BLOCK B - Elevation B Reference Elevation

GLAZING ALTERATION TYPE 21

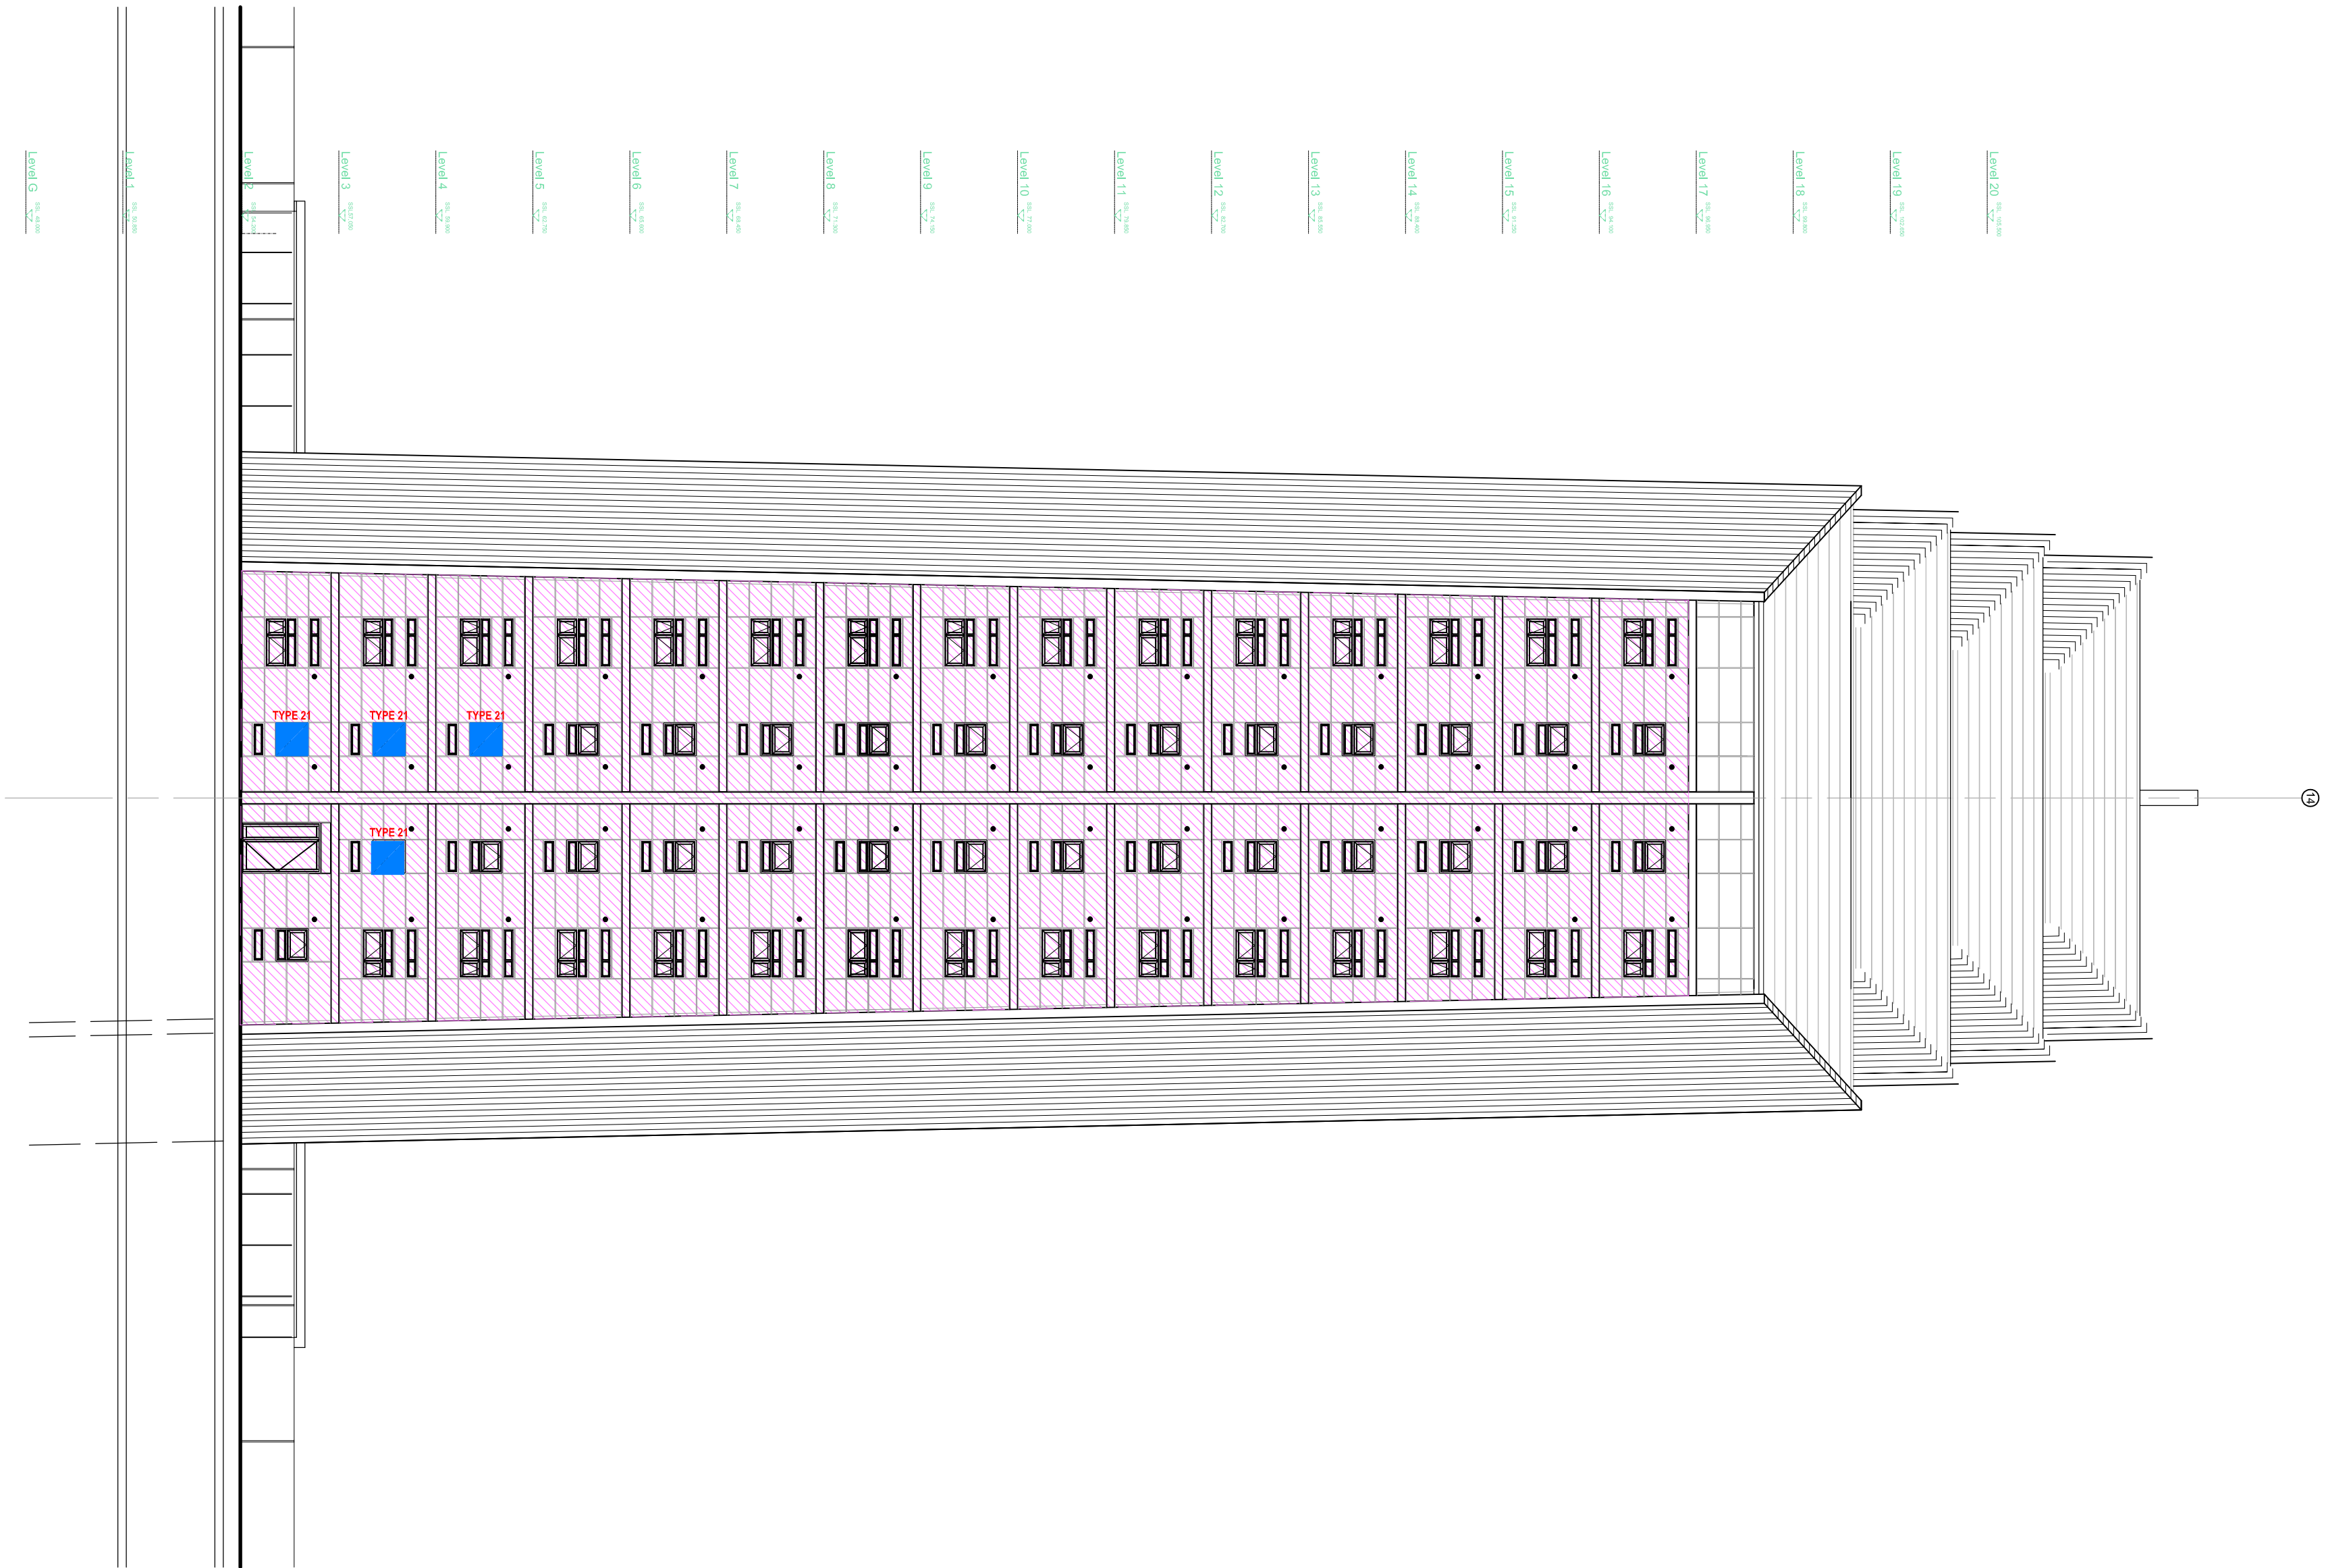
- Existing section of glazing replaced with new, single opening light to double opening light
- Apartment requiring additional mechanical extract ventilation to give 4 ACHr

New opening windows to be manufactured off site to match existing. All double glazed units to new windows to insited externally with 30l F-Prestige 40 lpm to match treatment to existing double glazed units. (new windows indicated in dark blue on reference elevation)

Application of solar control film externally to existing windows (indicated in light blue on reference elevation). Beading to be removed and re-instated once film is applied to full extent of double glazed unit. Any damaged elements in the course of the above to be replaced with new.

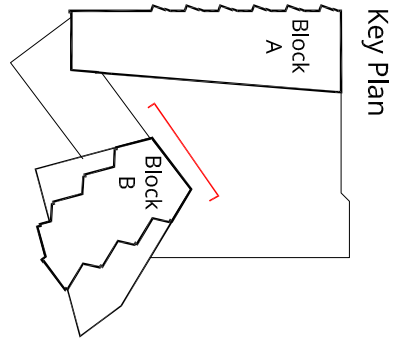
Type 21 window modification (4No.) - Replace existing windows with new 2 no. stacked opening lights.
